HISTORIC AND DESIGN REVIEW COMMISSION

May 15, 2019

HDRC CASE NO: 2019-260
ADDRESS: 107 N FLORES ST
LEGAL DESCRIPTION: NCB 122 BLK LOT 1 & 2
ZONING: D, H, RIO-7B
CITY COUNCIL DIST.: 1
DISTRICT: Main/Military Plaza Historic District
APPLICANT: David Hannan/Fisher Heck Architects
OWNER: All Out of Bubblegum LP
TYPE OF WORK: Storefront system replacement, window replacement, rehabilitation
APPLICATION RECEIVED: April 30, 2019
60-DAY REVIEW: June 29, 2019
CASE MANAGER: Edward Hall
REQUEST:

1 EAST EXTERIOR ELEVATION
3/16" = 1'-0"

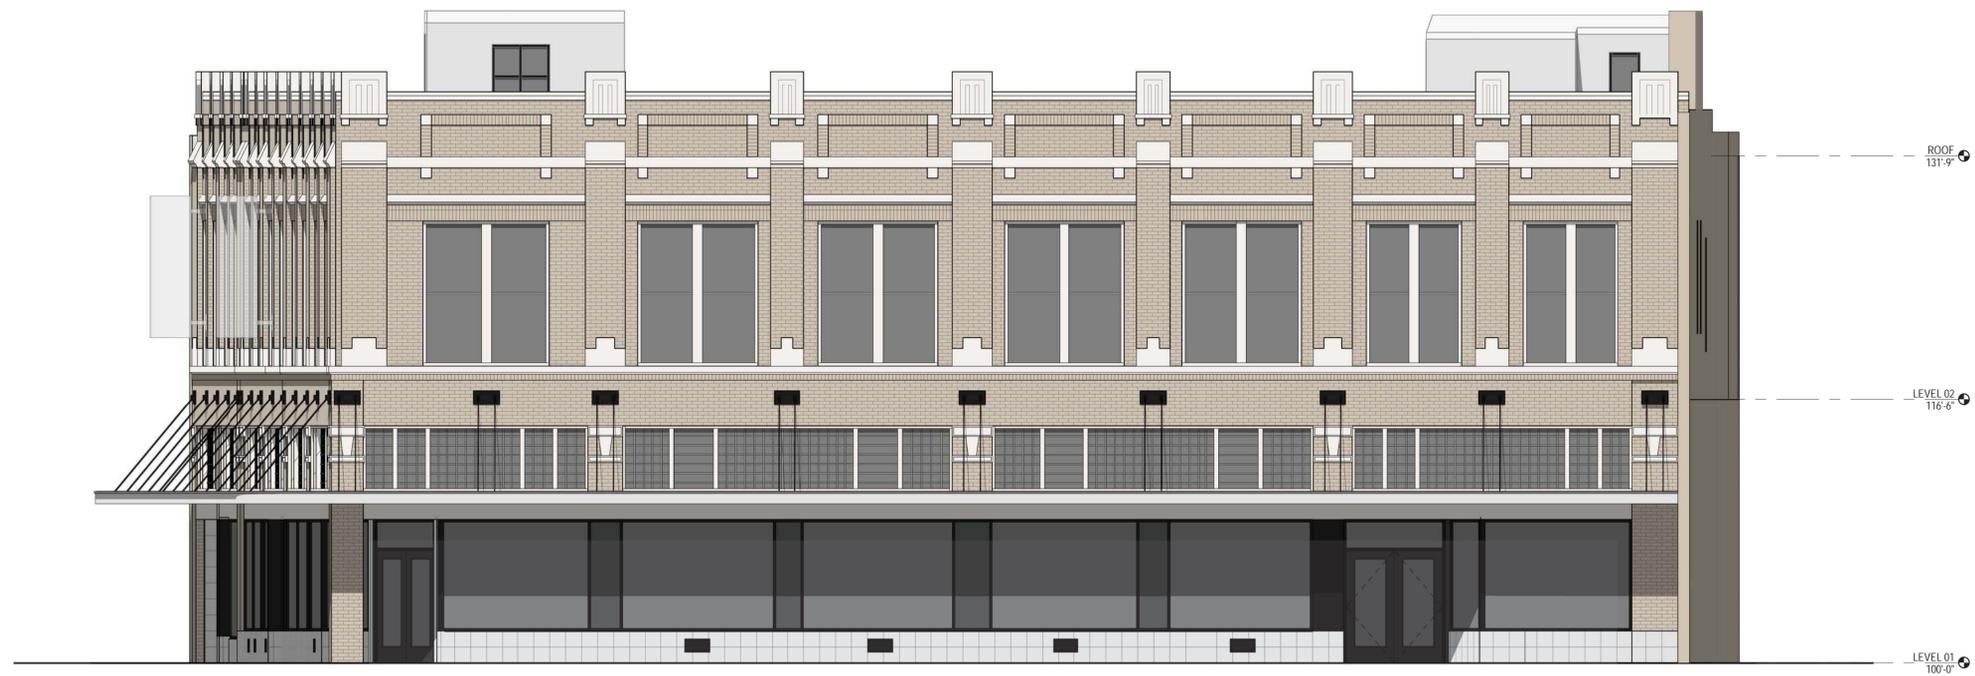
- c. **LIGHTING** – The applicant has proposed to install architectural lighting on both the south (E Commerce) and east (N Flores) facades. The proposed architectural lighting will illuminate both the underside of the street canopy as well as the facade above the canopy. Per the application documents, the proposed lighting will not cast illumination above the parapet wall. Staff finds the proposed lighting to be appropriate.

- d. **TRANSOM/CLERESTORY** – The historic structure originally featured transom windows above the ground level storefront which have been previously removed. At this time, the applicant has proposed to reintroduce these windows in the existing, enclosed openings. The applicant has proposed both the transom pattern and size of the

- e. **STOREFRONT REPLACEMENT** – The applicant has proposed to replace the existing, non-original storefront system with a new aluminum storefront system. The existing storefront system consists of aluminum frames and mullions. The applicant has proposed to install a new storefront system to feature wider, aluminum framed windows with smaller mullion profiles to match as closely as possible to those shown in historic photos, in regards to profile. Staff finds the reintroduction of storefront windows where openings have been previously enclosed to be appropriate. Additionally, staff finds the profile and window width as well as the reintroduction of spandrel panels on at column locations to be appropriate.

- i. That all rehabilitative scopes of work be done in-kind with like materials.
- ii. That the existing masonry be cleaned in a manner which does not cause permanent damage.
- iii. That the applicant submit product specifications for both the proposed transom windows and new storefront system.

WINDOW KEY PLAN

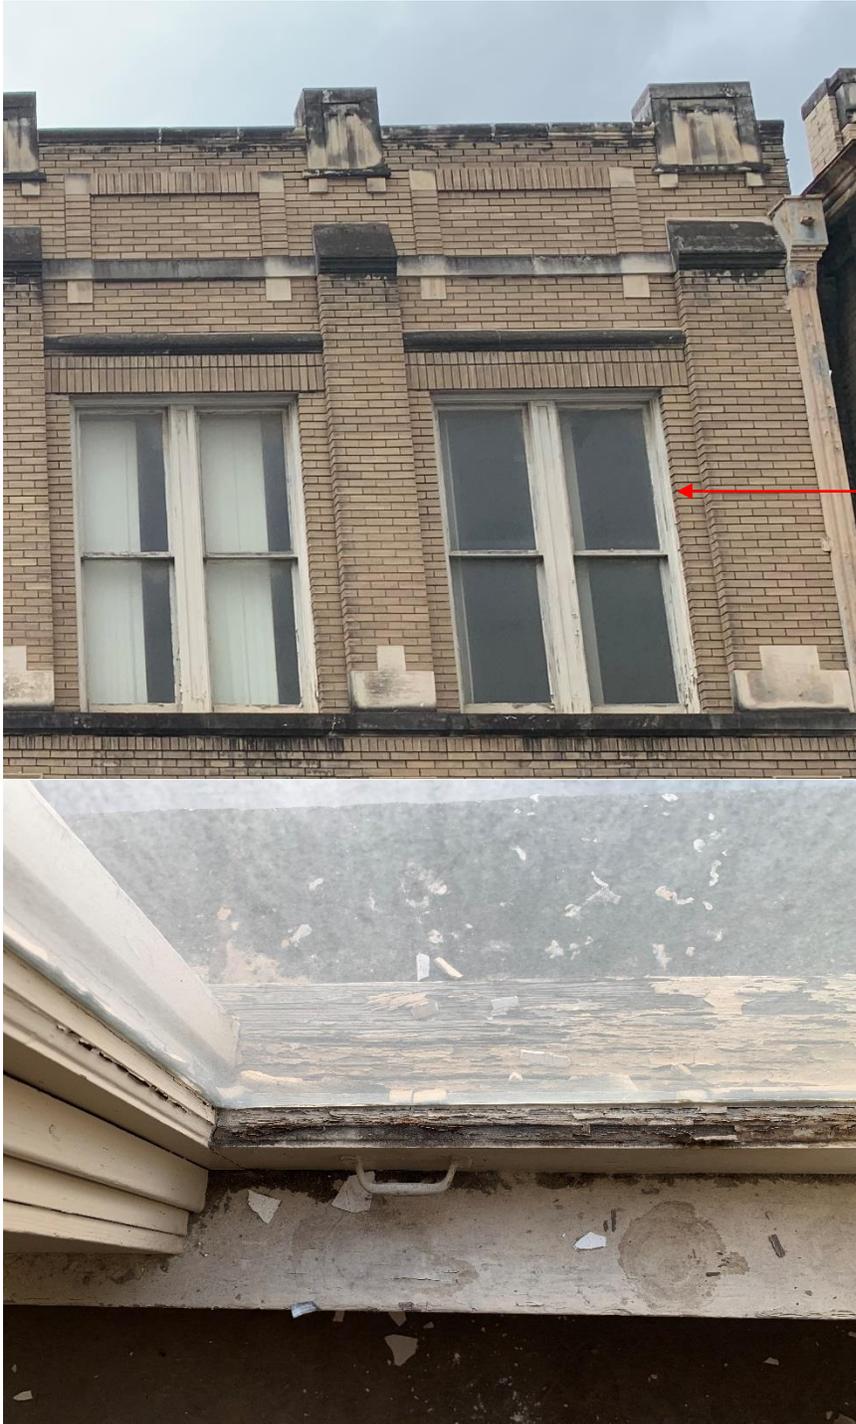
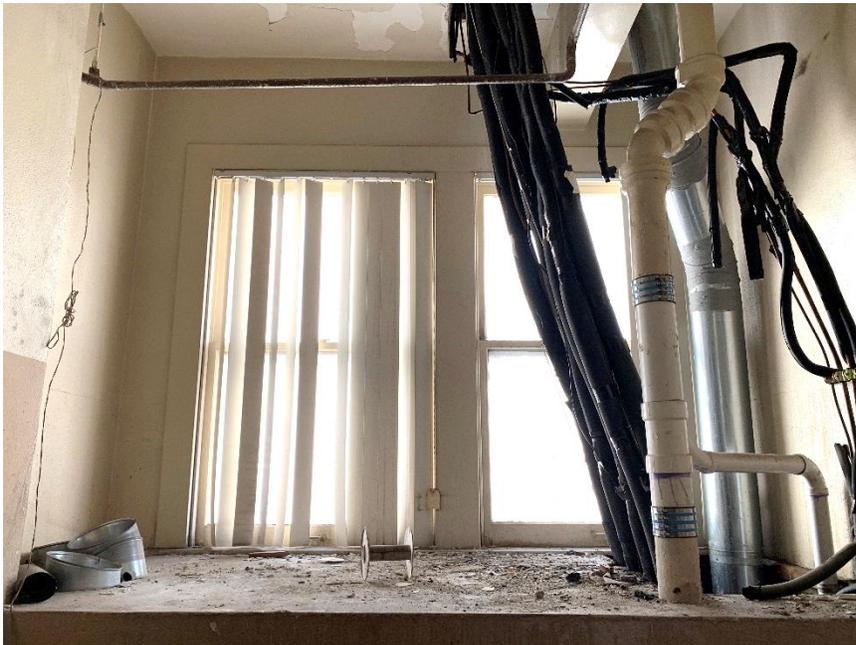
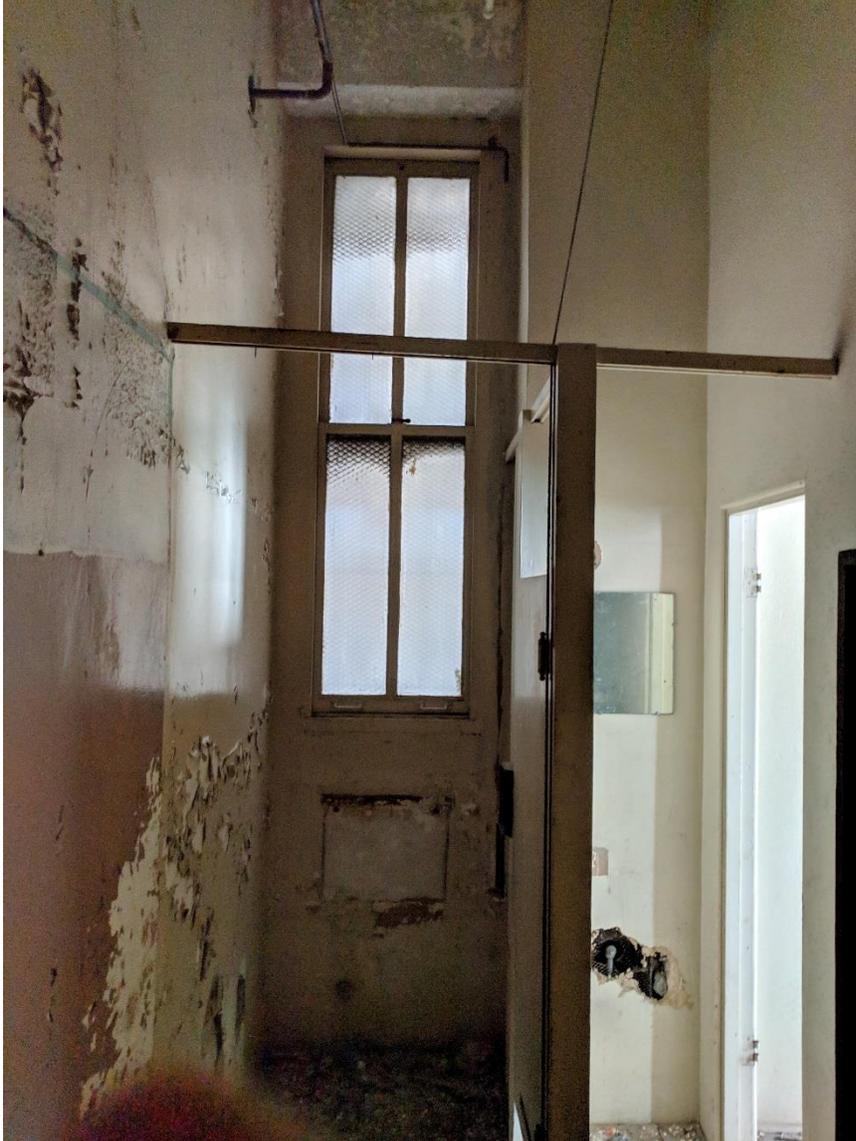
- f. **WINDOW REPLACEMENT** – The applicant has proposed to replace all of the original, wood windows on the second floor with new wood windows to feature a matching profile. The Guidelines for Exterior Maintenance and Alterations A.iii. notes that historic windows should be preserved. As noted in finding a, staff performed a site visit on March 11, 2019, where staff found that while some window sashes featured deteriorated or replacement parts, the windows were generally in repairable condition. The applicant’s proposed replacement is not consistent with the Guidelines. Staff finds that windows that are unable to be repaired, or those that are missing significant structural elements may be replaced in-kind, administratively.

Staff does not recommend approval of item #5, the replacement of the existing wood windows based on finding f. Staff finds that the window should be repaired. Windows that are unable to be repaired, or those that are missing significant structural elements may be replaced in-kind, administratively.
